Attachment 1
Class II-L Identification Methods Amendments, 2012
Rule Proposal

California Department of Forestry and Fire Protection (CAL FIRE)
Comments
October 19, 2012

Re: Public Comment - Class II-L Identification Methods Amendments, 2012 for Public Hearing on November 7, 2012

Figure 2: Illustration of difference in temperature profiles due to buffering.

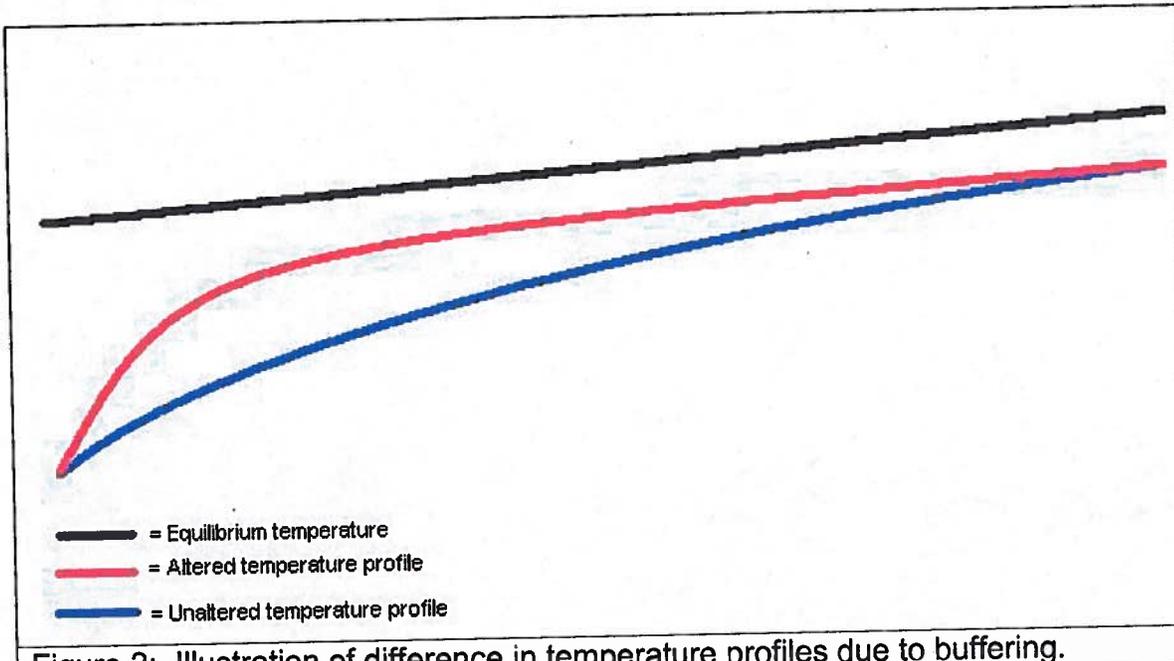
What the Literature Review does not do is recognize that the initial equilibrium temperature for such an example may not be “natural” and thus not meet the Basin Plan WQO for temperature in the first place. Given that equilibrium temperature is a fundamental concept in the stream temperature relaxation concept, it is notable that the *Literature Review* lacks any discussion that puts stream temperature dynamics in the context of equilibrium temperature. Equilibrium temperature is defined as the temperature that occurs when a balanced is achieved between heat sources and sinks (Bogan et al, 2003, Caldwell et al, 1991).

The second law of thermodynamics guarantees the temperature of a stream will trend towards the equilibrium temperature. Newton’s law of cooling tells us that the rate of temperature increase will be proportional to the difference between the waterbody’s temperature and the equilibrium temperature. This process continuously determines stream temperatures (Bogan et al, 2003). Effective management of stream temperatures for coldwater ecosystems is about limiting heat inputs to streams that are below equilibrium in order to minimize the rate of heating as the waterbody trends toward equilibrium (Figure 2).

In cases where water temperatures are relatively far from equilibrium temperature (such as downstream of springs, areas of high groundwater discharge, or melting snow) an increase in heat load may cause an increase in temperature that can't be mitigated by downstream conditions (Figure 3). In those situations the result is an acceleration of stream temperature in the downstream direction, rather than a localized increase quickly followed by an equal decrease. Management measures should be designed to prevent increased heat loads when the temperature of a waterbody is uniquely cold, regardless of stream classification.
